### APPEAL SUMMARY

**Status:** Decision Rendered - Reconsideration of ID 20825

<b>Appeal ID:</b> 21884	<b>Project Address:</b> 4804 SE Woodstock Blvd
<b>Hearing Date:</b> 9/18/19	<b>Appellant Name:</b> Charles Kidwell
<b>Case No.:</b> B-002	<b>Appellant Phone:</b> 503
<b>Appeal Type:</b> Building	<b>Plans Examiner/Inspector:</b> David Bartley
<b>Project Type:</b> commercial	<b>Stories:</b> 5 <b>Occupancy:</b> B, R-2, S-2 <b>Construction Type:</b> I-A, III-B
<b>Building/Business Name:</b> Modera Woodstock Apartments	<b>Fire Sprinklers:</b> Yes - Throughout
<b>Appeal Involves:</b> Erection of a new structure, Reconsideration of appeal	<b>LUR or Permit Application No.:</b> 19-117964-EA
<b>Plan Submitted Option:</b> pdf [File 1] [File 2] [File 3]	<b>Proposed use:</b> Multi-Family Residential

## White Paper - Fire Analysis of Fire Retardant Treated Wood Alternate

HORIZONTAL EXIT SEPARATION  
3-HR FIRE WALL for HORIZONTAL EXIT  
SEPARATION & ALLOWABLE AREA

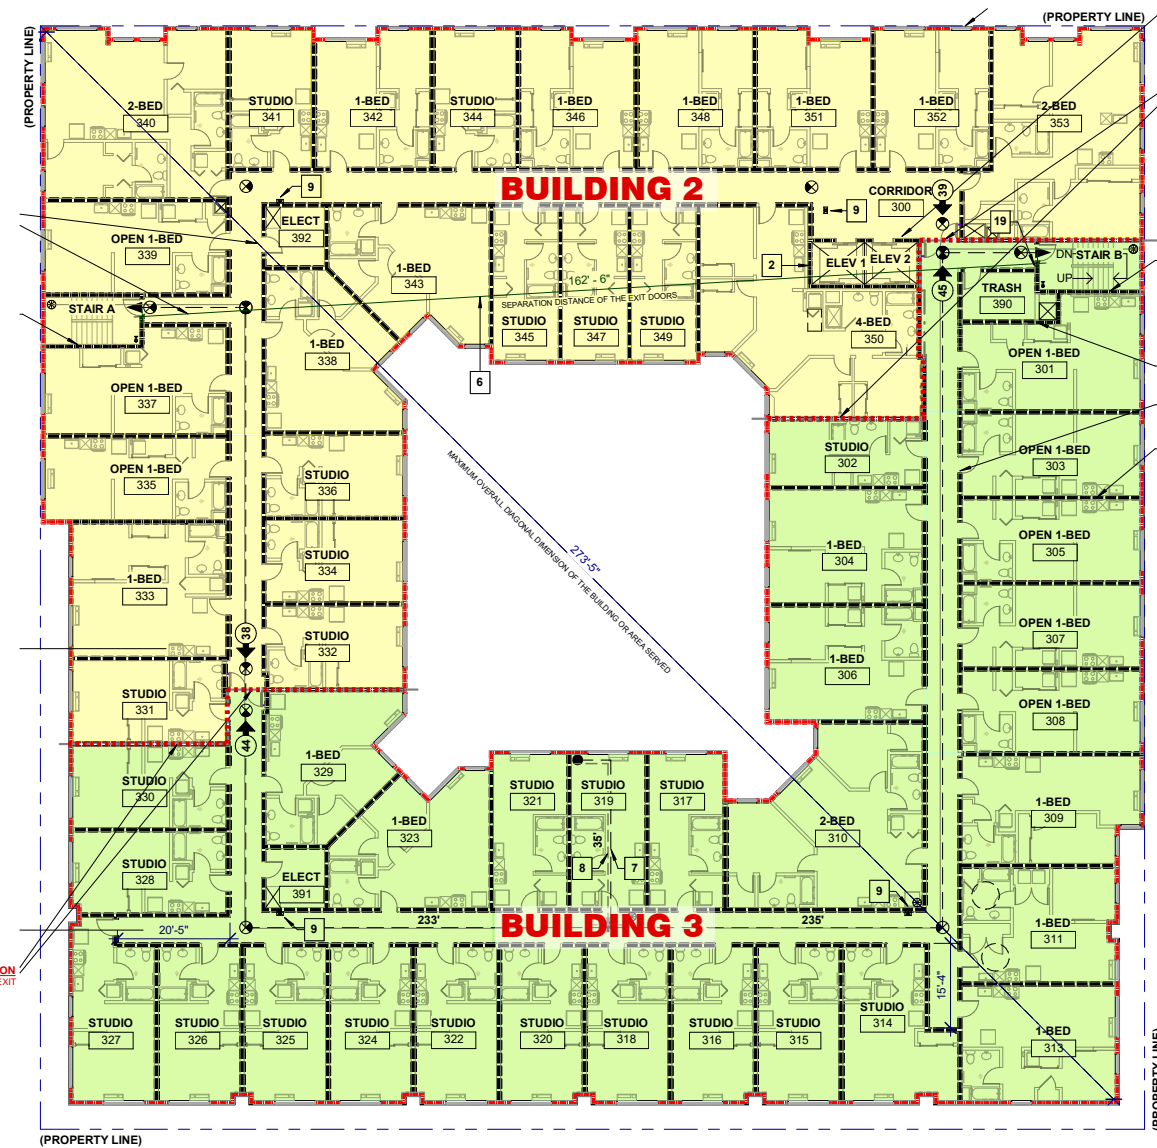
The proposed apartment building has total area of 147,995 sf. With the horizontal exit division wall,

each building compartment is reduced to nearly half of the allowable area using the 12,000 sf basic

allowable area. The proposed building configuration will meet the maximum allowable building area.

Appendix A; Figure 1: Exterior Wall

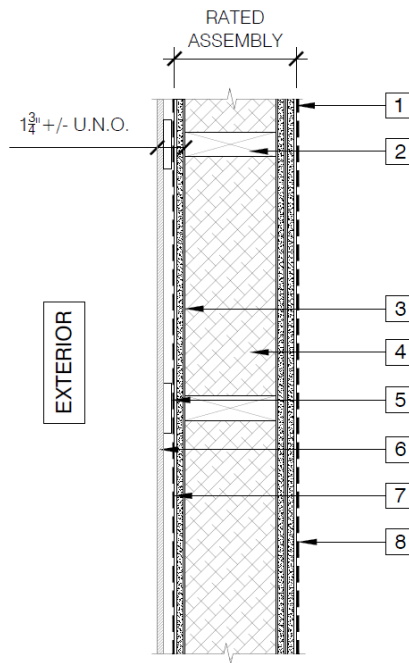
Exterior walls will be protected with non-combustible mineral wool insulation (in lieu of the Fire Retardant Treated wood framing) as explained in the attached white paper by Code Unlimited.

The exterior bearing walls in the Type IIIB buildings are permitted to be fire-retardant-treated (FRT) wood per 602.3. The proposed design consists of exterior walls with untreated wood stud framing with Roxul ComfortBatt mineral wool insulation at 2.0 lbs/ft

The White Paper established that ordinary lumber 2" X 6" exterior wall framing with mineral wool insulation friction-fit between studs will provide superior performance to an FRTW framed wall. The reason for requesting the Alternate Means & Method of construction is to provide relief from some additional requirements (Items #10 and #17 details 6, 7, and 8) imposed by the Code Guide when non-FRTW

**Use of mineral wool insulation with non-fire resistant treated wood framing in exterior walls of Type III construction: Granted provided special inspection is performed for installation of mineral wool.  
Appellant may contact John Butler (503 823-7339) with questions.**
